Modified Front View

The earlier set of drawings prompted several responses. Some I liked and some I didn't care for. We all agree that the budget was far more that we've ever paid before. That's because much of the materials are two and three times more expensive. I've endeavored again to keep the original ambience and cut where it seems logical to do so.

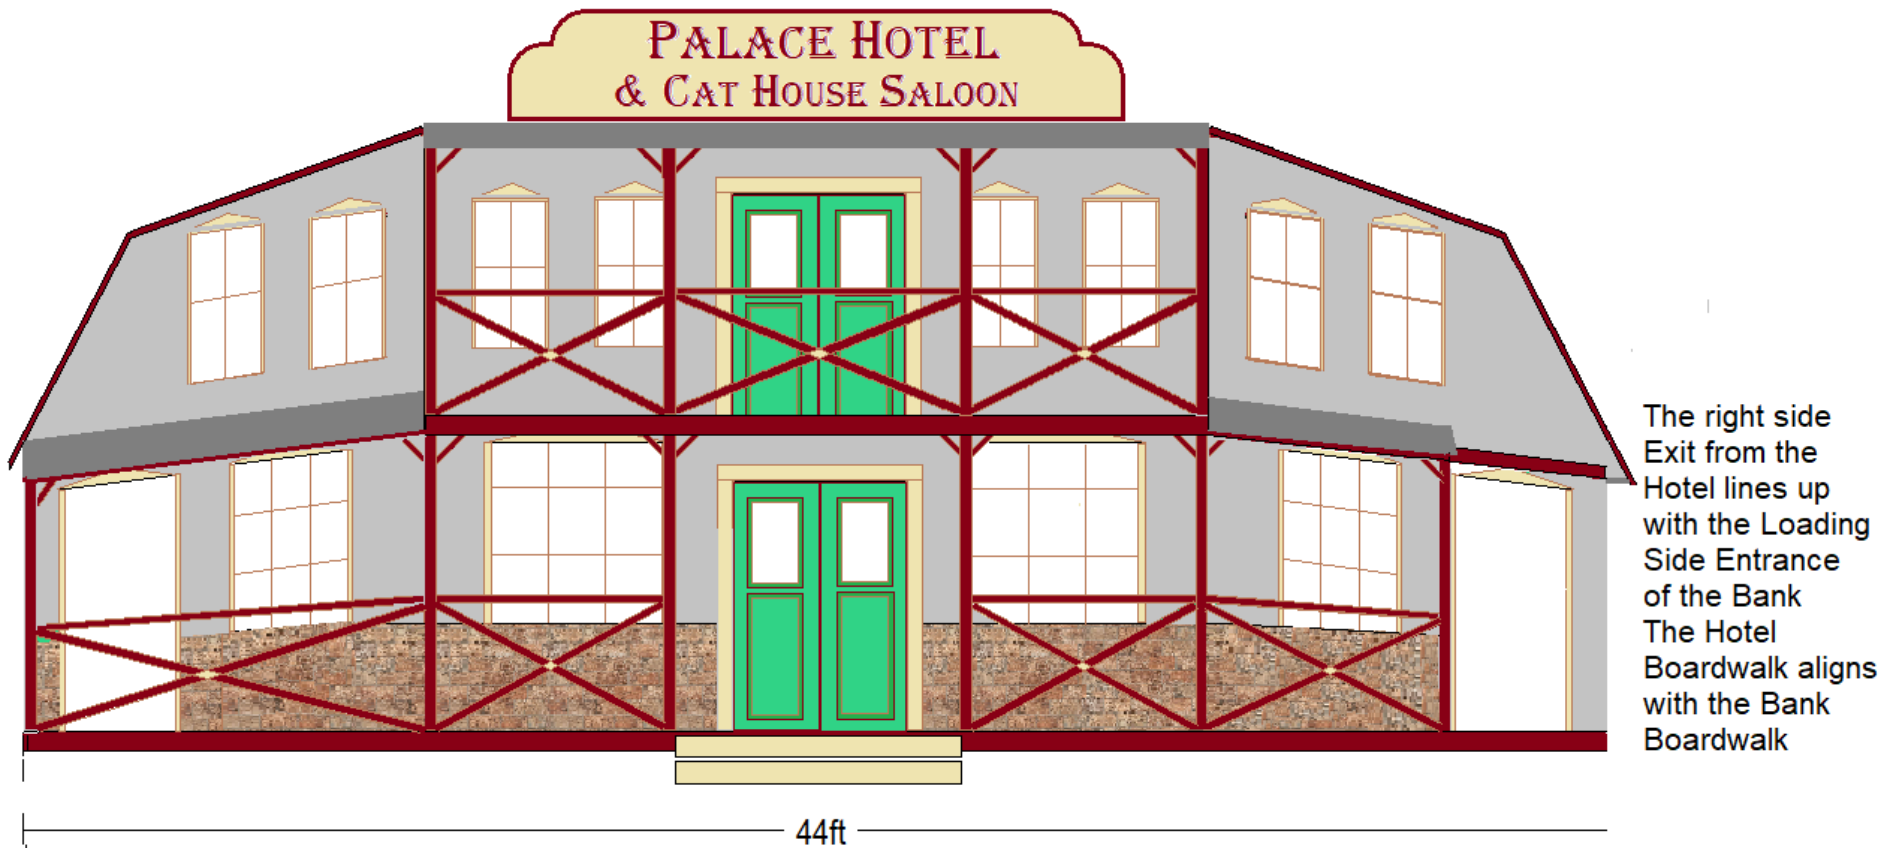
Attaching the hotel to the bank, much as we have done with many of our stages is a significant saving.

Modified Downrange View

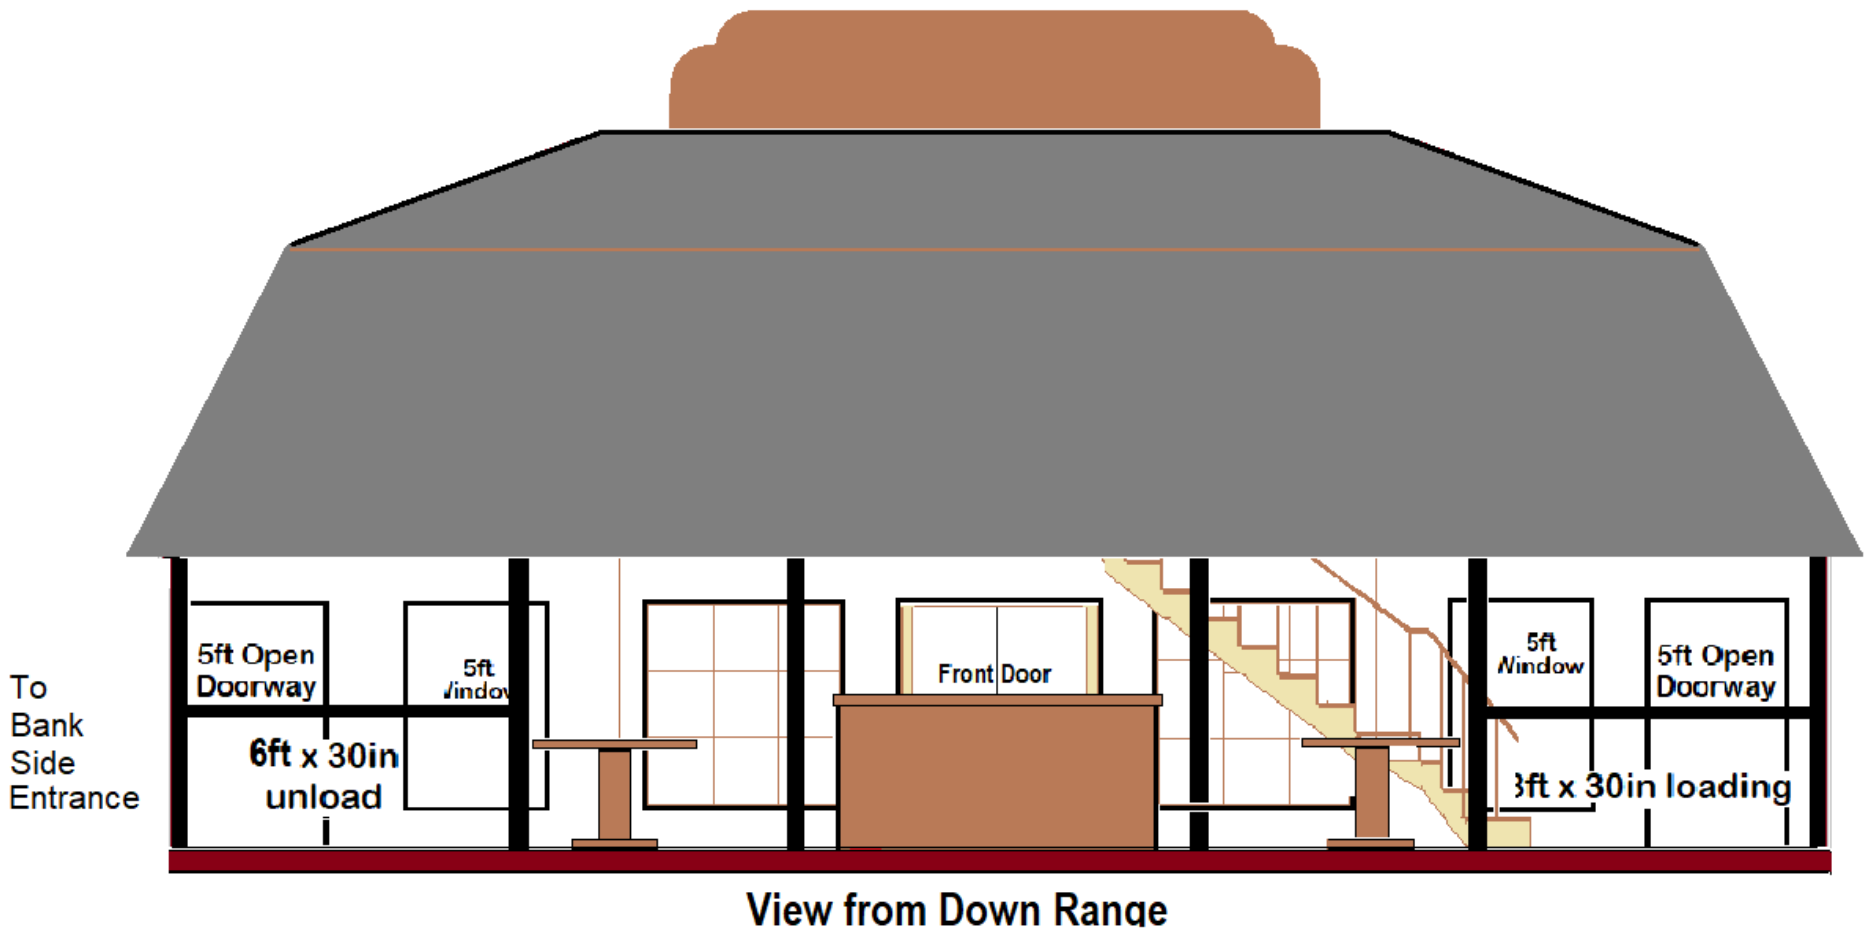
I discovered significant miss measurements in the height of the down range view. The firing line is still wide open with the highest open space above the firing line of all our stages.

Shooters may pass from the hotel to the Bank without ever leaving cover. The same will be true when passing from the General Store to the Hotel.

Page Three
Modified Bank Side View

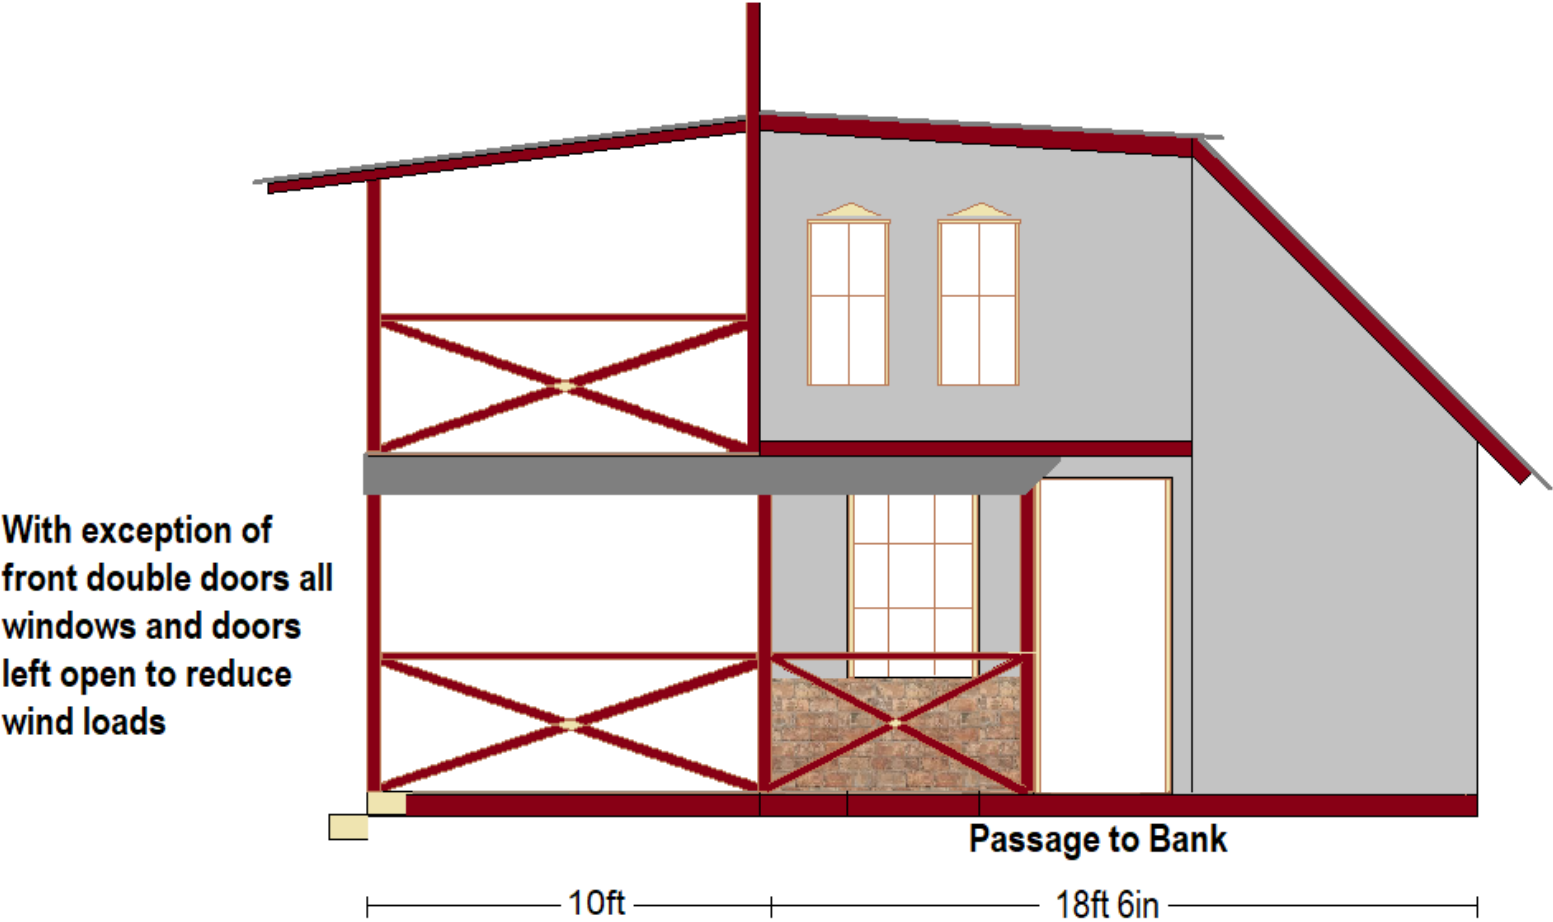
Adding a little color allows for a better understanding of how everything fits together.

Modified 2nd Floor View

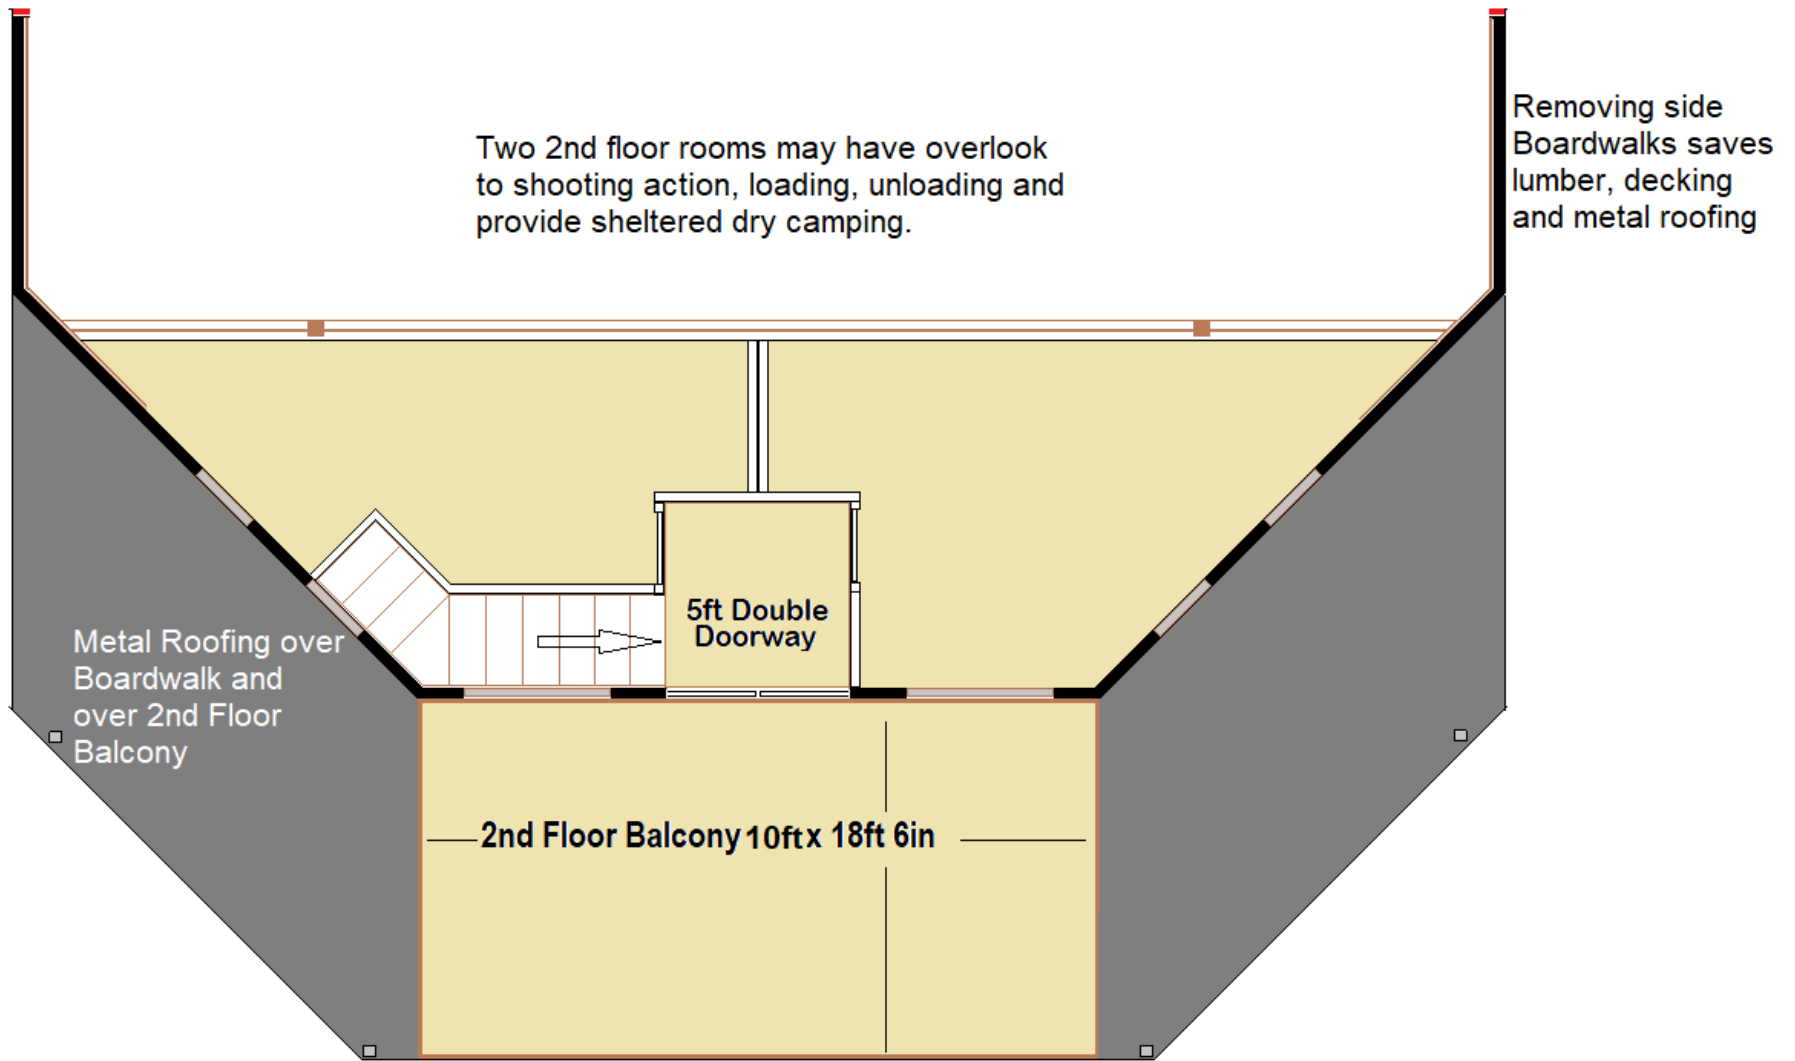
Possibly the biggest point of discussion will be the expanded 2nd Floor. The materials saving on the two side decks will be more than sufficient to deck the two rooms. Glenn suggested using the hotel as a gathering place. The 2nd Floor overlook makes the Hotel an even better place for after shoot gatherings.
